Norie's Bulletin of Corrections

No.4 from 1st October to 31st December 2019

Block correction for 2200.9 (Plan C)
 ILLNW 620/19

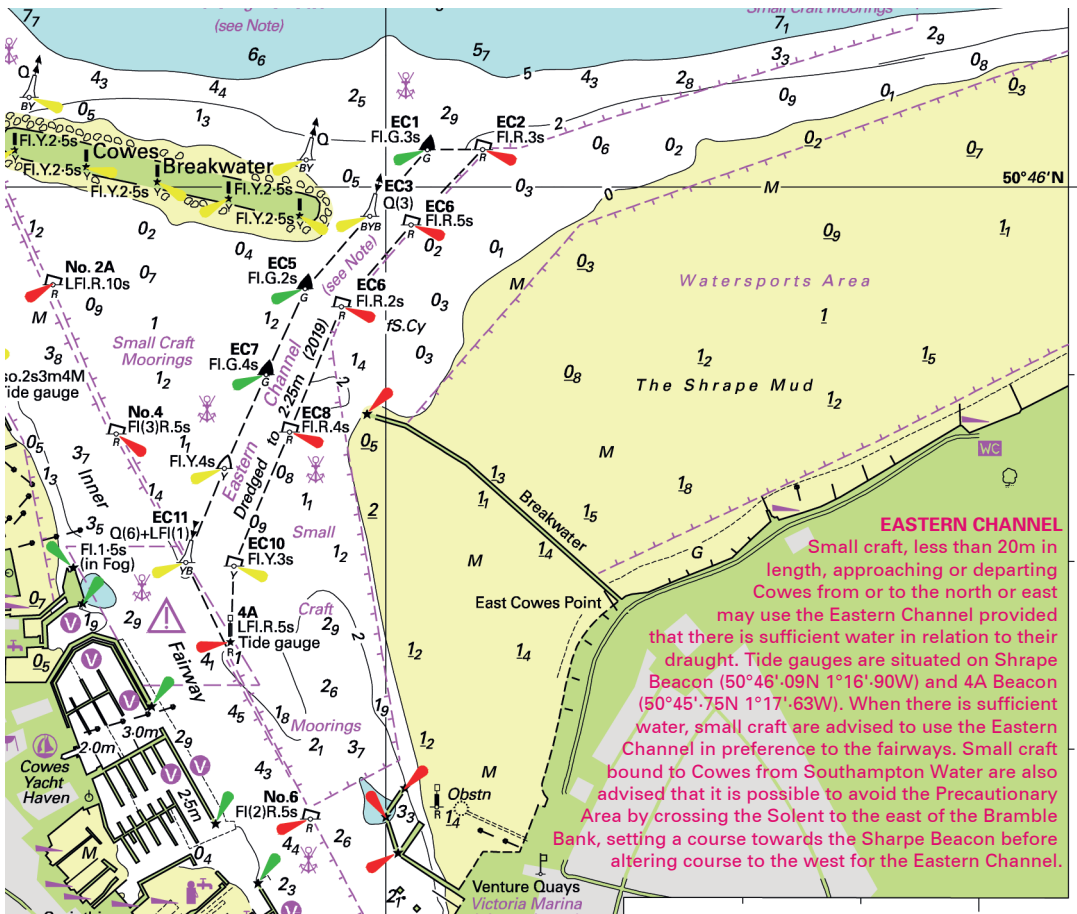
Insert accompanying block correction centred on 50°45'·92N 1°17'·37W (ILNW 620/19)
